National Highways Planning Response (NHPR 25-01) Formal Recommendation to an Application for Planning Permission

Council's Reference: AWDM/0233/26

Location: 113 Upper Brighton Road Worthing West Sussex BN14 9JD

Proposal: Secondary vehicular access to create in out driveway, new brick wall with piers

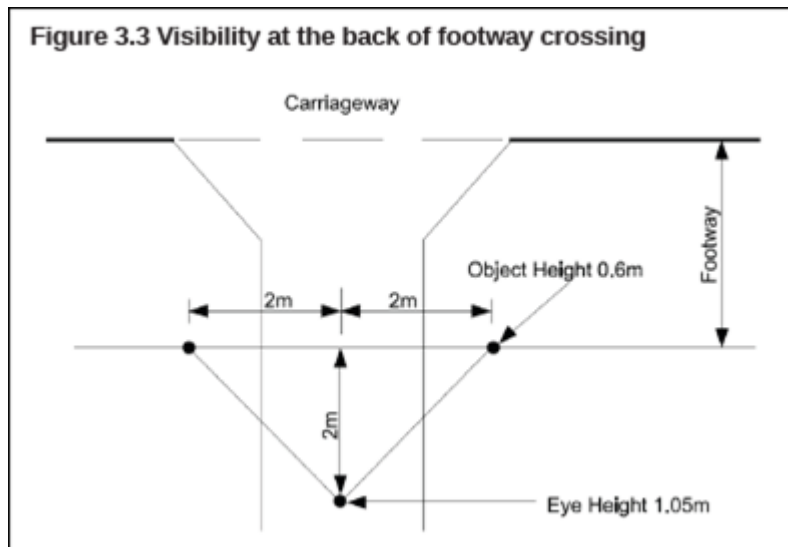
The proposed scheme shows truncated visibility splays of 4.5m x-distance and a 65m y-distance.

As the A27 is part of the SRN, visibility splays measured from the edge of carriageway must be in accordance with the standards in the Design Manual for Roads and Bridges. **The applicant will need to provide visibility splays which are required**

to be shown in full as per DMRB CD 123 to ensure that the visibility splays are clear of obstructions.

Clause 3.3 of DMRB CD 123 states that “where a direct access crosses a footway, a visibility splay shall be provided in accordance with Figure 3.3”. Figure 3.3 is shown below. A clear visibility splay measured from a point 2m from the rear of the footway, in each direction for 2m shall be provided.

- **An access design compliant with DMRB CD 123.** Any Departures must be justified and approved through National Highways' standard procedures.
- **Scaled drawings showing DMRB-compliant visibility splays and the proposed access geometry.**
- **Swept paths for the largest anticipated vehicle, demonstrating safe access and egress in forward gear.**
- **A Walking, Cycling and Horse-riding Assessment and Review (WCHAR) will be required in accordance with DMRB GG 142, or an exemption note will need to be submitted.**
- **A Stage 1 Road Safety Audit which will need to be satisfactorily completed in accordance with DMRB GG 119.**
